ACS-2 PUIS Update to Power Management States

April 21, 2009

Revision 3

Figure 1 — Power Management State Diagram

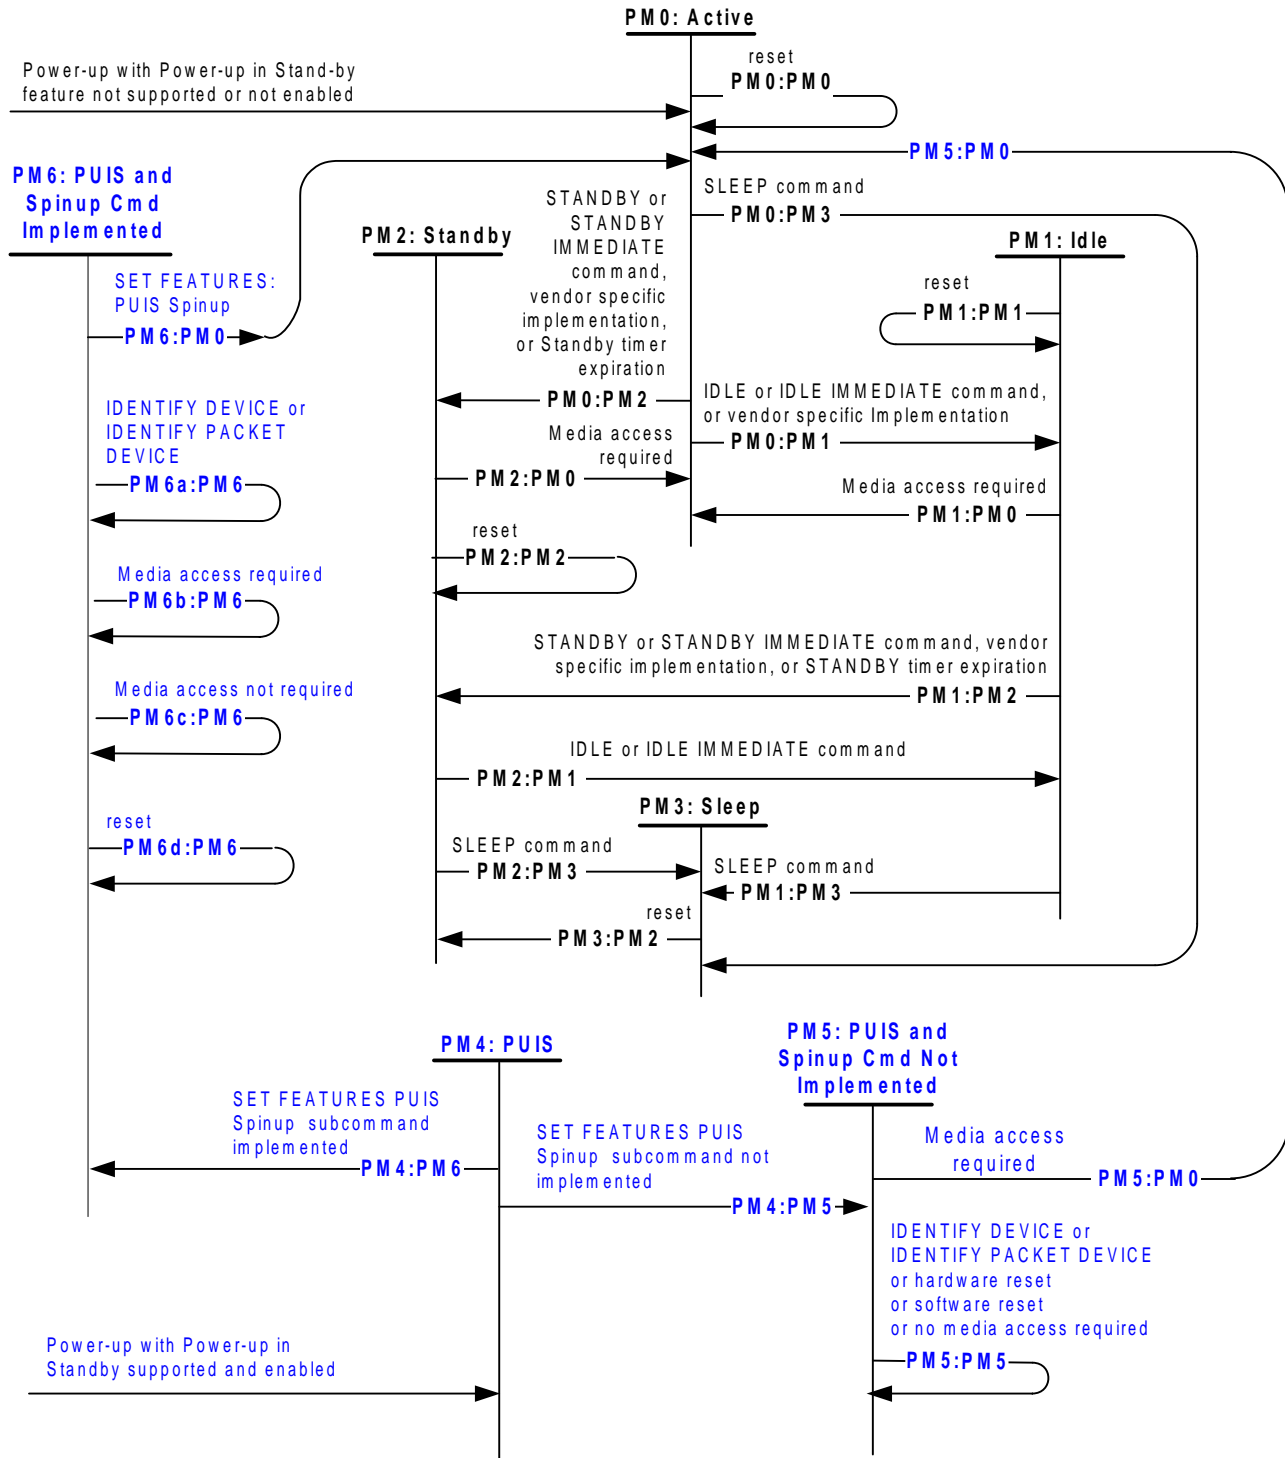
PM0:Active: This state shall be entered when the device receives a media access command while in Idle or Standby mode. This state shall also be entered ~~after processing a power-on reset if when the device is powered-up with~~ the Power-Up In Standby feature is not ~~supported implemented~~ or ~~is~~ not enabled (see 4.2).

- a) the device successfully processes a STANDBY command;
- b) the device successfully processes a STANDBY IMMEDIATE command;
- c) the Standby timer expires;
- d) the NV Cache power mode timer expires;
- e) a device performs an optional vendor specific internal power management function;
- f) ~~the device is powered-up with the Power-Up In Standby feature implemented and enabled;~~ or
- g) the device successfully processes a hardware reset, a software reset, or a DEVICE RESET command while in PM2:Standby or PM3:Sleep.

~~If the PUIS feature set is enabled, then:~~

- h) ~~if the device implements the optional SET FEATURES PUIS feature set device spin-up command, then~~
 - A) ~~if the a SET FEATURES PUIS feature set device spin-up command is received, then the device shall transition to the PM0:Active state; or~~
 - B) ~~if the a SET FEATURES PUIS feature set device spin-up command has been processed then:~~
 - a) ~~if media access is required, then the device shall transition to the PM0:Active state.~~

PM4:PUIS: This state shall be entered when after processing a power-on reset if the PUIS feature set is supported and is enabled.

Transition PM4:PM5: A device shall transition to the PM5:PUIS No Spinup Implemented state if the device does not implement the optional SET FEATURES PUIS feature set device spin-up command (see [editors note: 7.52.8 in ACS-2]).

Transition PM4:PM6: A device shall transition to the PM6:PUIS Spinup Implemented state if the device implements the optional SET FEATURES PUIS feature set device spin-up command.

PM5:PUIS No Spinup Implemented: This state shall be entered when after processing a power-on reset if the PUIS feature set is supported and is enabled and the device does not implement the optional SET FEATURES PUIS feature set device spin-up command.

Transition PM5:PM0: A device shall transition to the PM0:Active state after processing a command, other than IDENTIFY DEVICE or IDENTIFY PACKET DEVICE, that requires media access.

Transition PM5:PM5: A device shall transition to the PM5:PUIS No Spinup Implemented state after processing an IDENTIFY DEVICE or IDENTIFY PACKET DEVICE command, any hardware or software reset, or any command that does not require media access.

PM6:PUIS Spinup Implemented: This state shall be entered when after processing a power-on reset if the PUIS feature set is supported and is enabled and the device implements the optional SET FEATURES PUIS feature set device spin-up command.

Transition PM6:PM0: A device shall transition to the PM0:Active state after processing a SET FEATURES PUIS feature set device spin-up command.

Transition PM6a:PM6: A device shall transition to the PM6:PUIS Spinup Implemented state after processing IDENTIFY DEVICE or IDENTIFY PACKET DEVICE command.

Transition PM6b:PM6: The device shall transition to the PM6:PUIS Spinup Implemented state after returning command aborted in response to a command, other than IDENTIFY DEVICE or IDENTIFY PACKET DEVICE, that requires media access.

Transition PM6c:PM6: A device shall transition to the PM6:PUIS Spinup Implemented state after processing a command, other than IDENTIFY DEVICE or IDENTIFY PACKET DEVICE, that does not require media access.

Transition PM6d:PM6: A device shall transition to the PM6:PUIS Spinup Implemented state after processing a hardware reset, software reset, or DEVICE RESET command.
